SUBJECT: ORDER FOR MODIFICATION OF LICENSE CONCERNING PRIMARY COOLANT
SYSTEM PRESSURE ISOLATION VALVES

SAFETY EVALUATION REPORT
SALEM NUCLEAR GENERATING STATION, UNIT NO. 1
PRIMARY COOLANT SYSTEM PRESSURE ISOLATION VALVES
(WASH-1400, EVENT V)

**PRIMARY COOLANT SYSTEM
PRESSURE ISOLATION VALVES**
PUBLIC SERVICE ELECTRIC & GAS COMPANY
SALEM UNIT 1

NRC DOCKET NO. 50-272

Figure 1. Valve Configurations Designated by the NRC To Be Included in This Technical Evaluation

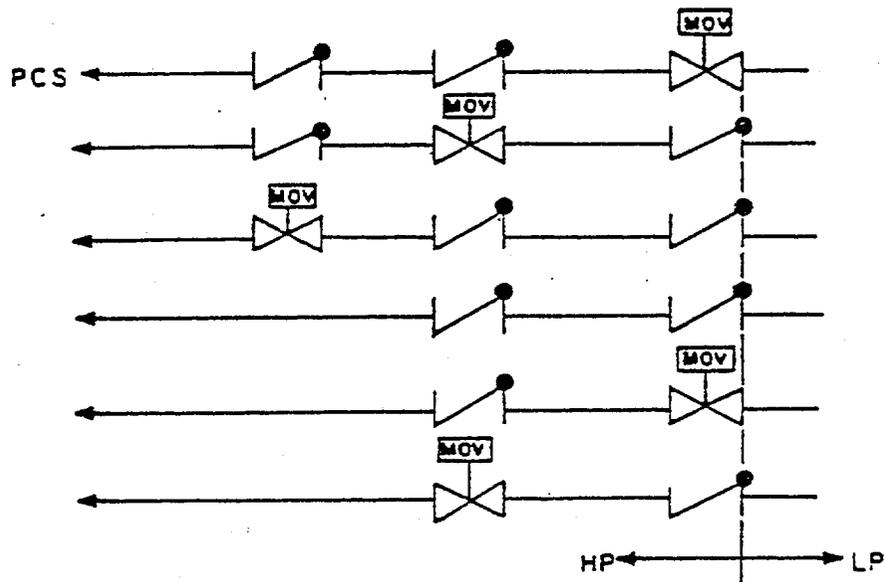
For a piping system to have a valve configuration of concern, the following five items must be fulfilled:

- 1) The high-pressure system must be connected to the Primary Coolant System;
- 2) there must be a high-pressure/low-pressure interface present in the line;
- 3) this same piping must eventually lead outside containment;
- 4) the line must have one of the valve configurations shown in Figure 1; and
- 5) the pipe line must have a diameter greater than 1 inch.
